**Sent:** 31/08/2020 5:22:27 PM  
**Subject:** Development DA2020/0816 - 33 Bassett Street Mona Vale - Objection  
**Attachments:** Bassett Street Objection Report.pdf;

**DEVELOPMENT APPLICATION DA 2020/0816  
23-33 BASSETT STREET MONA VALE  
PROPOSED RESIDENTIAL CARE FACILITY UNDER SEPP HOUSING  
FOR SENIORS**

This document is a submission by way of objection to Development Application 2020/0816 (the 'development application') relation to Nos 23 - 33 Bassett Street Mona Vale (the 'subject property').

**Figure 1-** North elevation showing west boundary of site and relationship with adjoining cottage style development

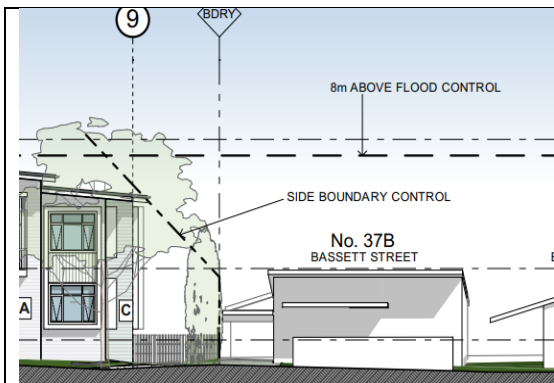
This site is not in a medium density residential zone nor is the property located in a mixed use commercial type environment. The fact that the site is zoned for 'low density residential' purposes should be instructive to the applicant as far as the development proposal is concerned. This is especially the case where low density residential extant development is to be replaced by a high density facility (over the eastern part of the land). We contend that the architect has failed to take into account the reasonable expectations of adjoining land owners and occupiers in this regard. Figures 1 and 2 below show the relationship between the proposal and adjoining development to the east and west (source Gartner Trovato Architects). In our opinion the separation between the built elements in Figure 1 is not acceptable.

**Figure 2-** North elevation showing east boundary of site and relationship with adjoining cottage style development

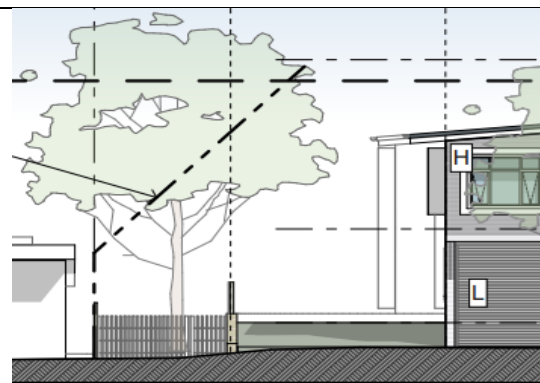
In our view the building should be broken into at least two built elements crossways, so that some respect can be paid to the built form of existing cottages in other parts of this streetscape (with their narrow frontages), the relevant low density zone and the PDCP character statement suggesting that vegetation should be integrated with development. In this case the reduced street setbacks will not allow for sufficient planting to soften this bulky and very lengthy facade.

Below is an extract from the drawings by Gartner Trovato Architects, showing the length of proposed building (around 95m total), when viewed from Bassett Street. The long, unarticulated length of this facade, is completely uncharacteristic of adjoining and nearby development. As Council will be aware the existing building is at odds with the nearby building character. When this bulk is extended for a further distance along Bassett Street, a significant change in the dominant character of the southern side of Bassett Street will result. In our minds this is particularly undesirable.
